South Texas Project Electric Generating Station P.O. Box 289 Wadsworth, Texas 77483

March 6, 2008
NOC-AE-08002255
10CFR50.90

South Texas Project
Units 1 and 2
Docket Nos. STN 50-498, STN 50-499
Proposed Amendment to Technical Specification 3.8.3.1

Subject: Proposed Amendment to Technical Specification 3.8.3.1

3.8.3.1

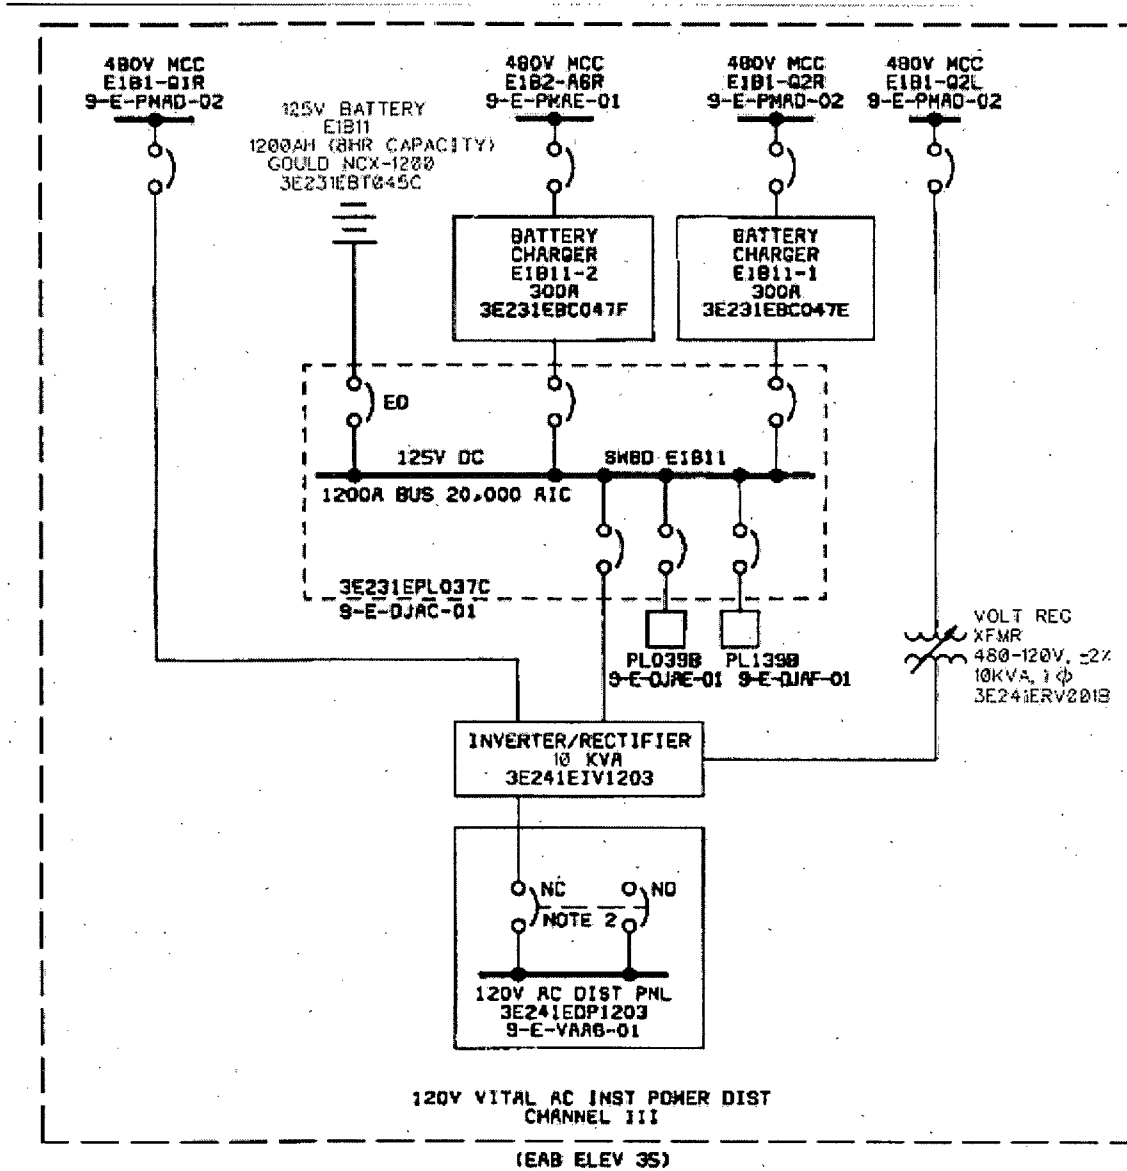
ACTIONS c and d of TS 3.8.3.1 allow the option of calculating risk-informed completion time (RICT) for DP1201, DP1202, DP1203, DP1204 in accordance with the requirements of the CRMP. This option may not be applied for DP001 or DP002 because none of the functions on these distribution panels are modeled in the PRA. TS 3.8.3.1 establishes separate ACTIONS e and f for these distribution panels that provides 30 days to energize the affected panel from its associated inverter connected to their associated DC bus. ~~Although the functions are not risk-significant,~~ Because of the low risk-significance of the affected functions on DP001 and DP002, the fact that, once energized from the voltage regulating transformer, the functions are still powered from a diesel-backed 1E source, and the low likelihood of an initiating event and subsequent equipment failures, the 30 day completion time is acceptable. ~~a RICT cannot be quantified in accordance with the requirements of TS 6.8.3.k.~~
